Permit Application Review

Permit No. 2018-120  
Received complete: November 20, 2018

Applicant: Jennifer Rehder.; Dow DuPont  
Consultant: Tim Setala; Pierce Pini and Associates  
Project: Parking Lot Expansion for Film Tec  
Location: 7215 Cahill Road: Edina  
Rule(s): 4,5,11,12  
Reviewer: BCO

**1 UTILITY PLAN**  
 NORTH  
 0 20' 40' 60'  
 1"=20'

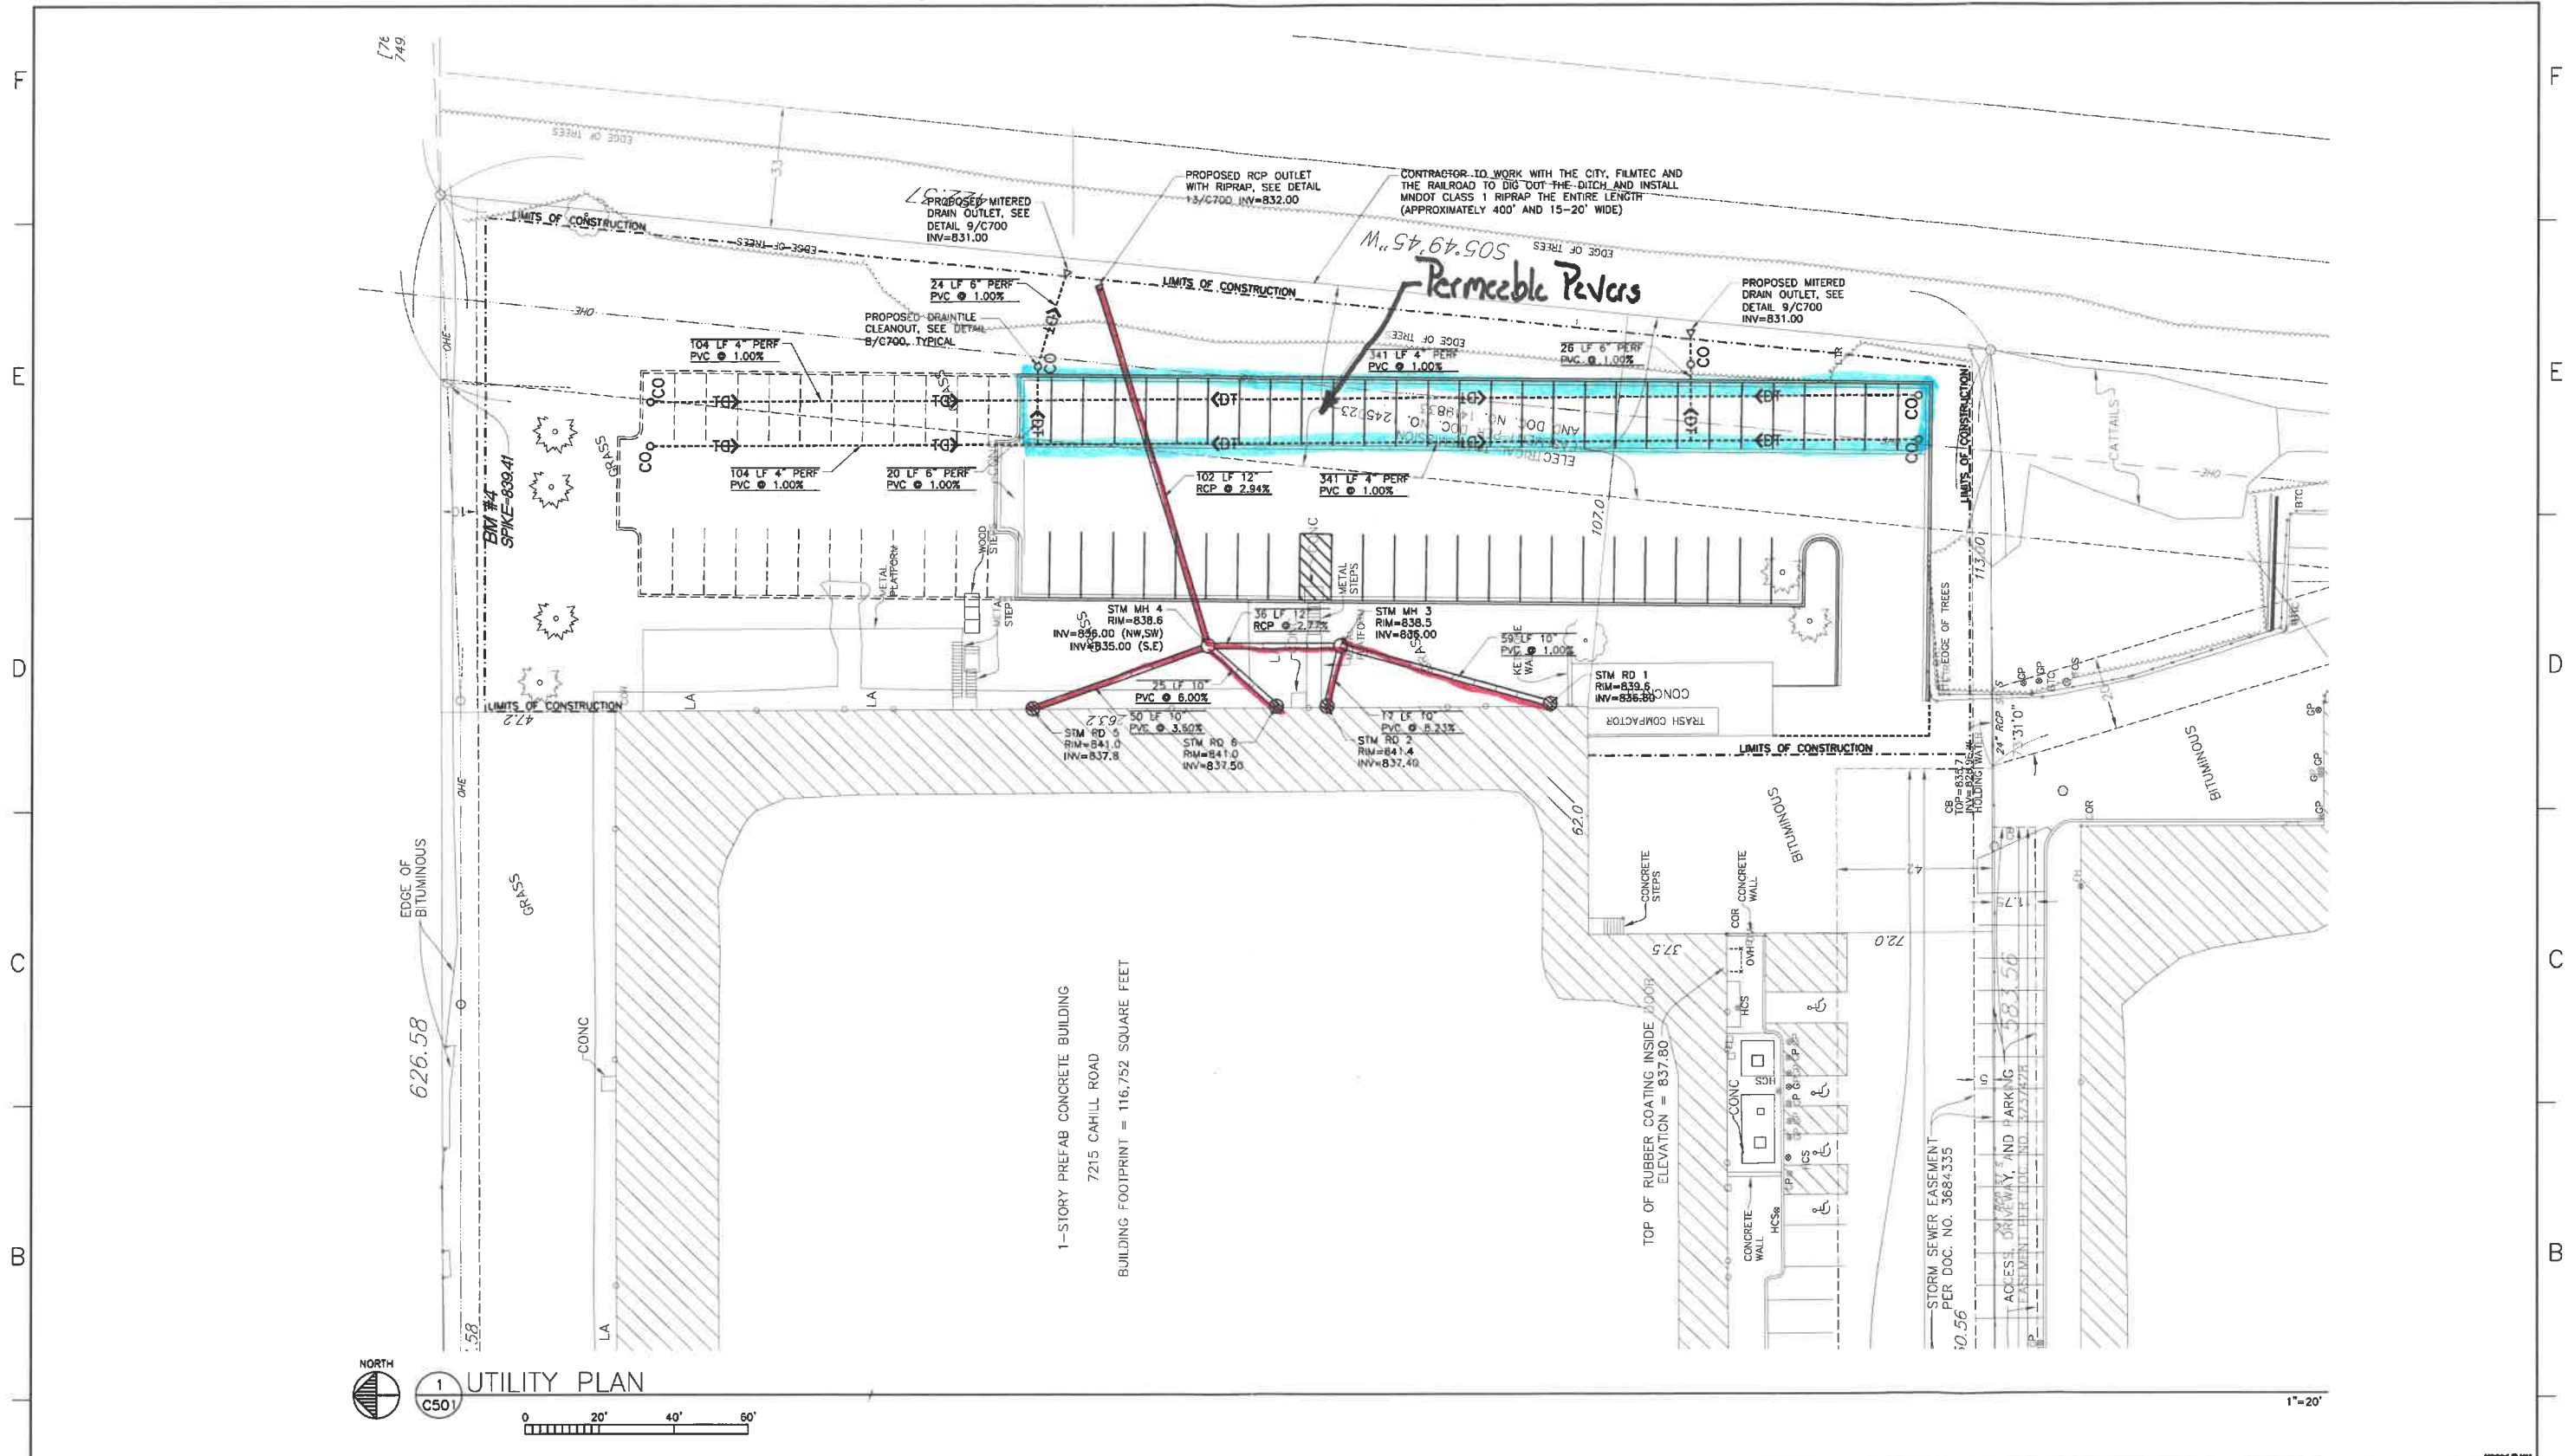
Stormwater management, volume retention, rate control and water quality management will be provided within the section of permeable pavers to be used for 40 of the 77 proposed parking stalls to be constructed.

An infiltration volume of 599 cubic feet is required from the 6,534 square feet of new impervious area. The soils information provided indicates the underlying soils is poorly graded sand (SP) having an infiltration rate of 0.45 inches/hour using the Minnesota Storm Water Manual. A volume of 2,892 cubic feet will be provided by the permeable pavers section (599 cubic feet required). An area of 333 feet is required, an area of 11,626 square feet provided, for volume retention using this infiltration rate. This is based on a maximum allowable

inundation depth of 1.8 feet within the paver subbase with a required drawdown in 48 hours (4.3.1a (ii)).

The geotechnical information submitted indicates that groundwater was encountered at elevation 826 M.S.L. The bottom of the rock section for the pavers is 830.3 M.S.L., a separation of 4.3 feet. A three (3) foot separation is required between the bottom of an infiltration facility and groundwater.

The HydroCAD modeling provided shows elevation 833.1 M.S.L. as the calculated 100-year frequency flood elevation within the paver system. The finished floor of the existing building is 837.8 M.S.L., a 4.7 foot separation. District Rule 4.3.3 states that a stormwater management facility must be constructed at an elevation that ensures that no adjacent habitable building will be brought into noncompliance with a standard in subsections 4.3.3 c, requiring at least two feet of separation provided between the 100-year high water elevation of a constructed facility and the low floor elevation of a structure. Rule 4.3.3 is met.

1. Per Rule 4.5.6, an as-built drawing of the storm water facilities, including a stage-volume relationship in tabular form, for the retention area within the permeable paver section conforming to the design specifications as approved by the District must be submitted.
